# CITY OF ALBUQUERQUE

**Re: Lot 10 Block 9 Unit 22 Volcano Cliffs, S.A.D. 228  
6401 Petirrojo Rd. NW  
Request Permanent C.O. – Not Accepted Q/O  
Engineer's Stamp dated: 4-11-17 (D10D003121)  
Certification dated: 10/21/17**

LOT 10, BLOCK 9, UNIT 22  
VOLCANO CLIFFS SUBDIVISION

CANDELARIA - COMPOS - GRADING & DRAINAGE PLAN

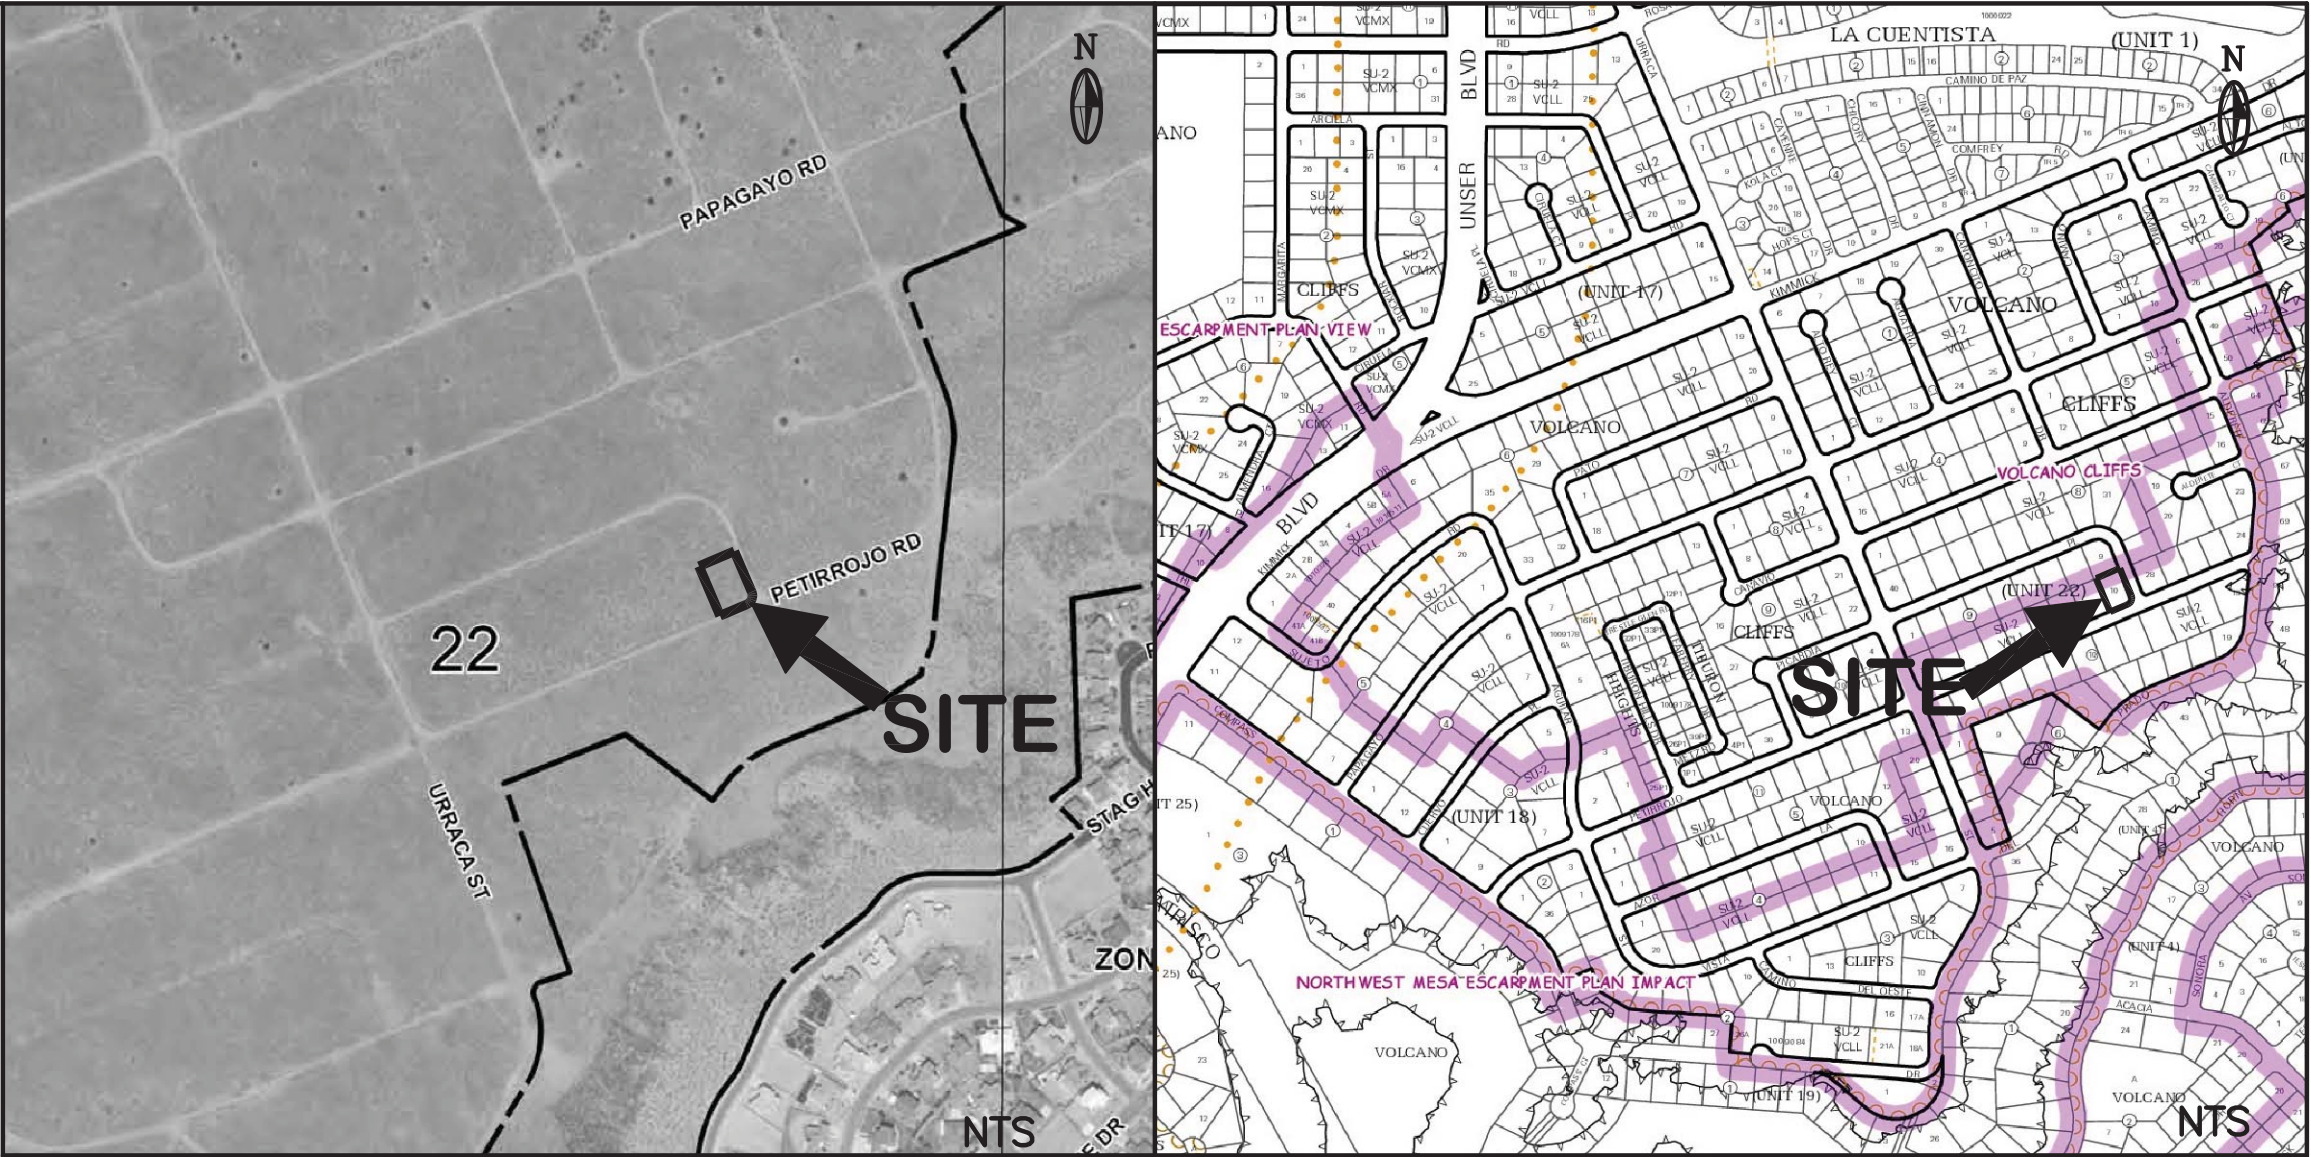
- The garden wall was built without a permit and the approved G&D plan was not submitted.
- The area surrounding the site is not clear of debris and trash. This area must be clean and not contain any leftover materials for proper drainage.
- The east side yard appears to allow flows to exit over the side walk before entering the water quality pond.
- Remove the trash bin in the rear yard.
